STATE PROJECT NOS. 409-02-0016 and 836-08-0073
FEDERAL AID PROJECT NO. 3606(518)
ROUNDAABOUT INTERSECTION AT LA 406 and LA 407
ROUTES LA 406 and LA 407
ORLEANS PARISH

SUBJECT: ADDENDUM NO. 1 (CONSTRUCTION PROPOSAL REVISION)
ELECTRONIC BIDDING AMENDMENT NO. 1

ROUNDABOUT INTERSECTION

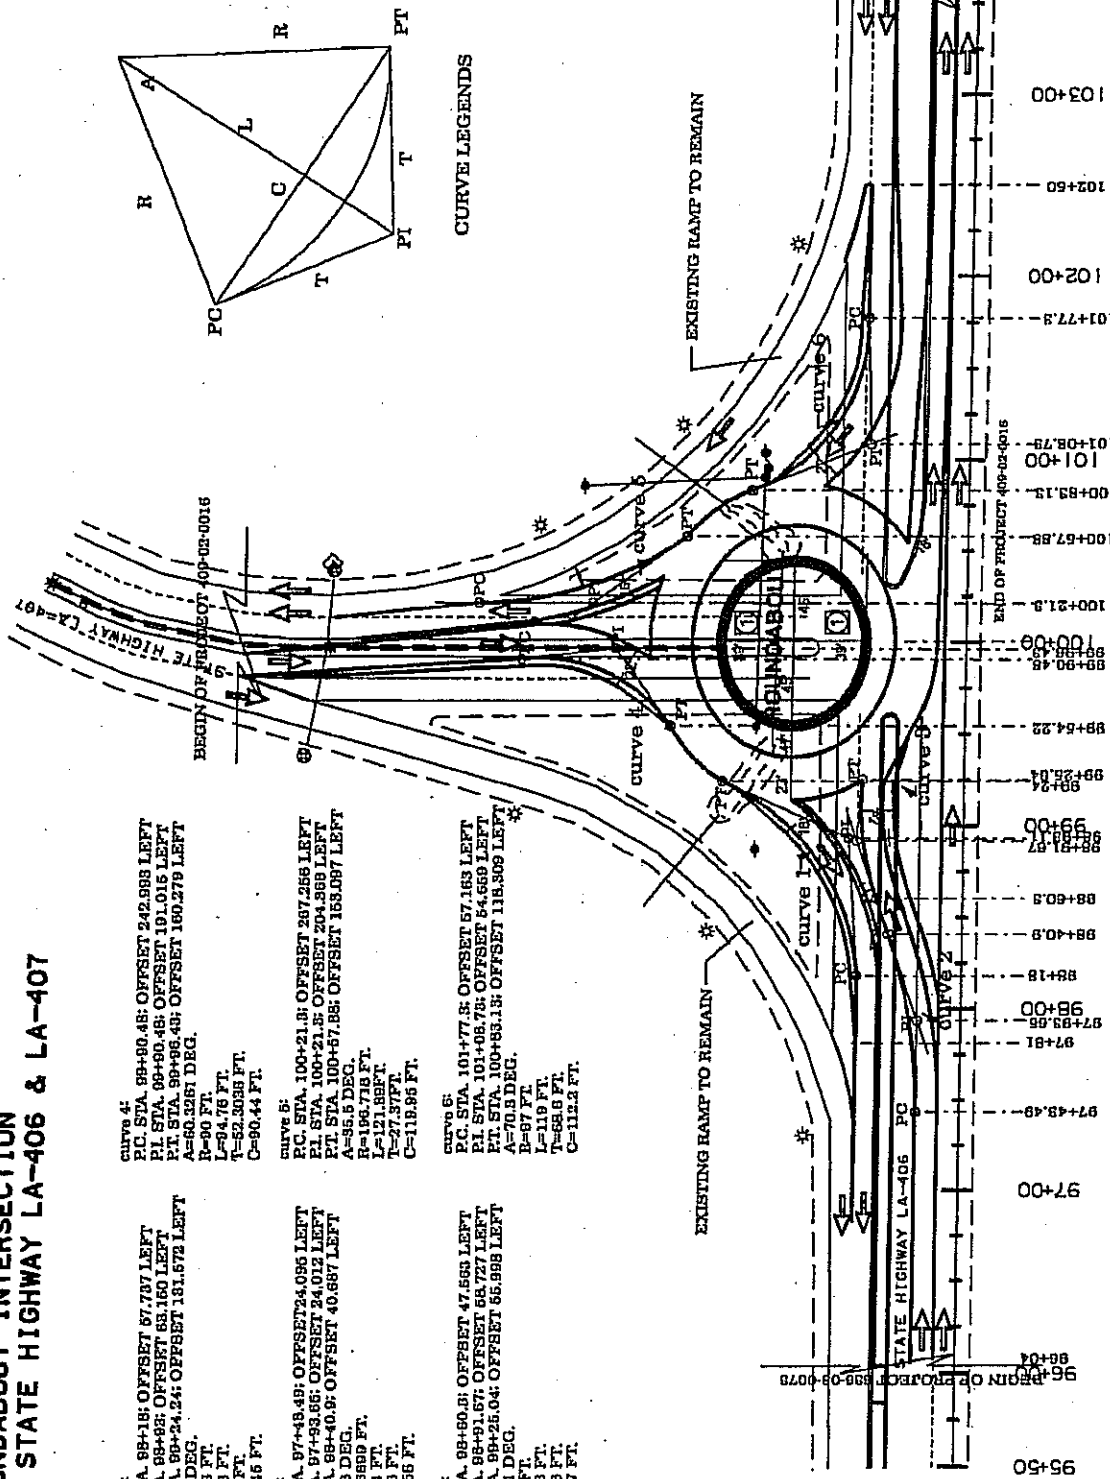
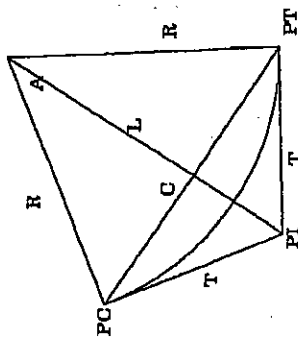
SHEET NO. 4		PARISH ORLEANS		DESIGNED CHECKED		ADDED ADDITIONAL DIMENSIONS AND REVISED LAYOUT		CMG	
FEDERAL PROJECT HES-3006 (S1B)		STATE PROJECT 409-02-0016 & 836-08-0073		DATE		BY		SHEET	
REVISION DESCRIPTION									
NO. DATE									
PLAN VIEW									
ROUNDABOUT WOODLAND HWY. AT LA 407									
DISTRICT 13

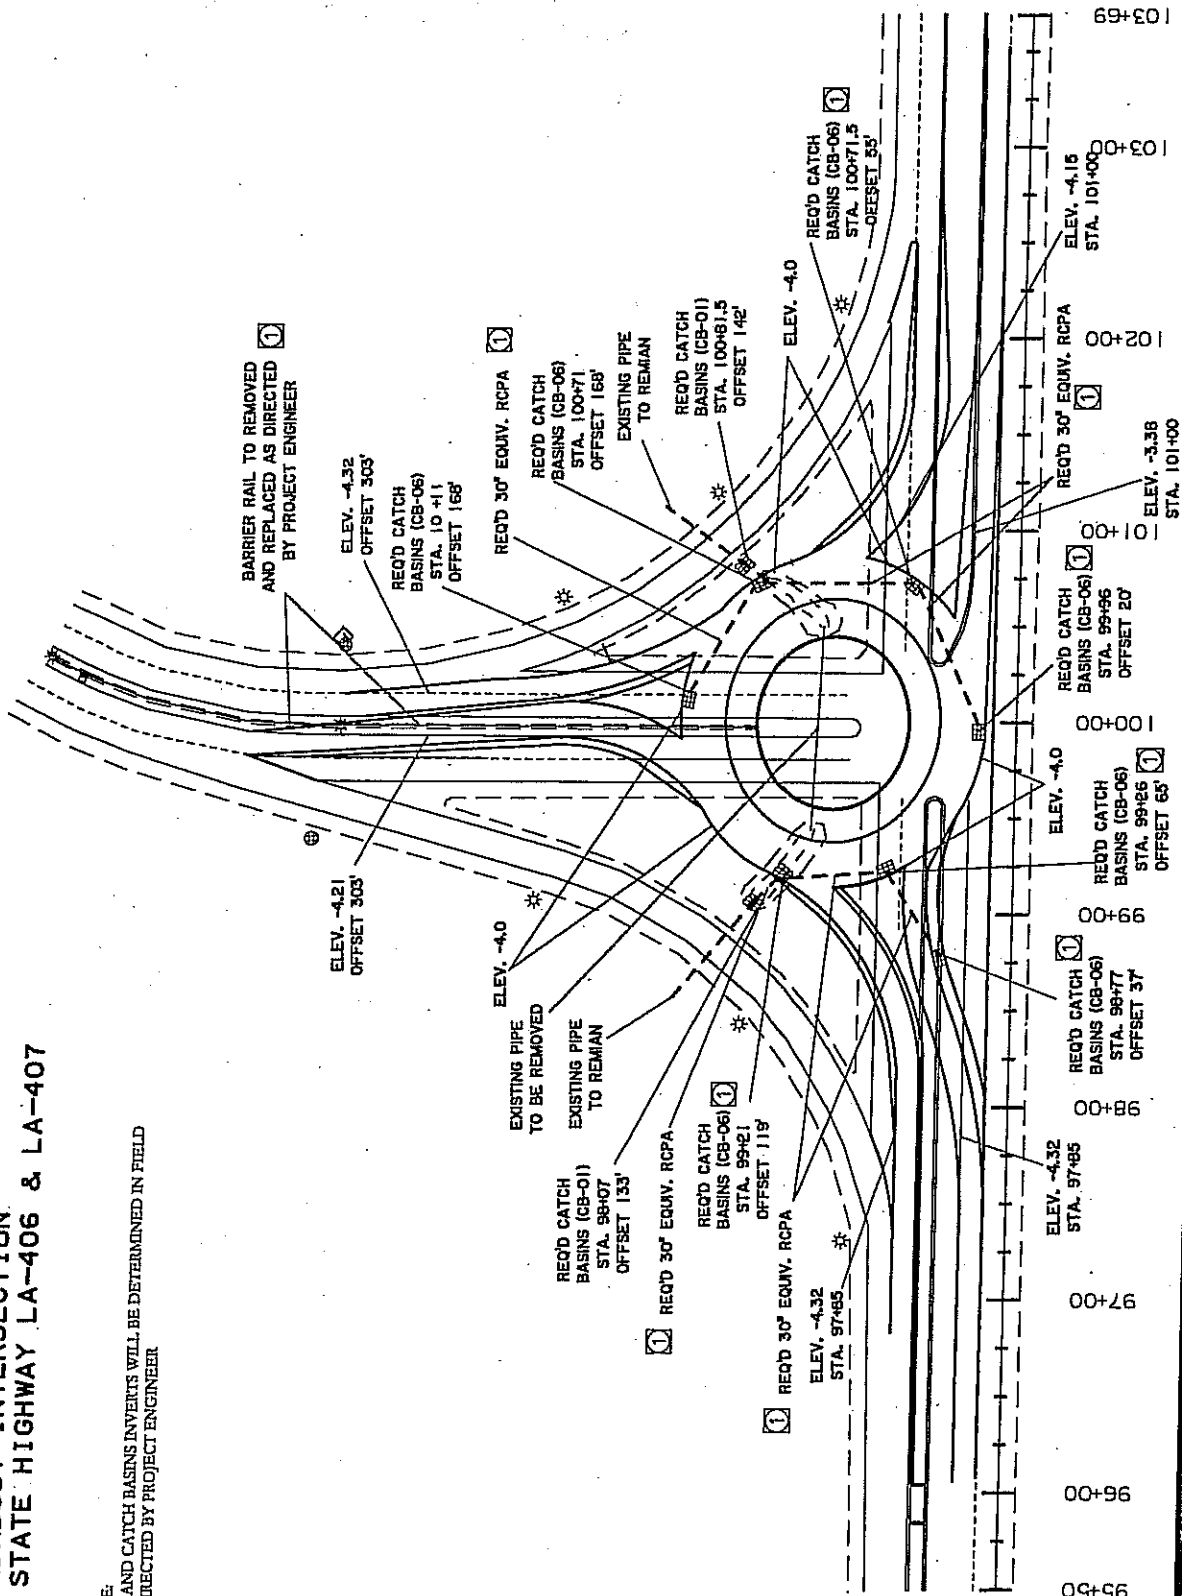
SHEET NO. 40		PARISH ORLEANS		FEDERAL PROJECT HDS-3606 (518)		STATE PROJECT 409-02-0016 & 836-08-0073	
DESIGNED CHECKED		CMG		REVISED AND ADDED NOTES, REVISED LAYOUT		8/20/09	
DETAILED CHECKED						NO. DATE	
DATE				REVISION DESCRIPTION		PLAN VIEW	
DISTRICT 02 DESIGN		ROUNDABOUT WOODLAND HWY. AT LA 407		bota		DISTRICT 02 DESIGN

NOTE:
PIPE AND CATCH BASIN INVERTS WILL BE DETERMINED IN FIELD
AS DIRECTED BY PROJECT ENGINEER
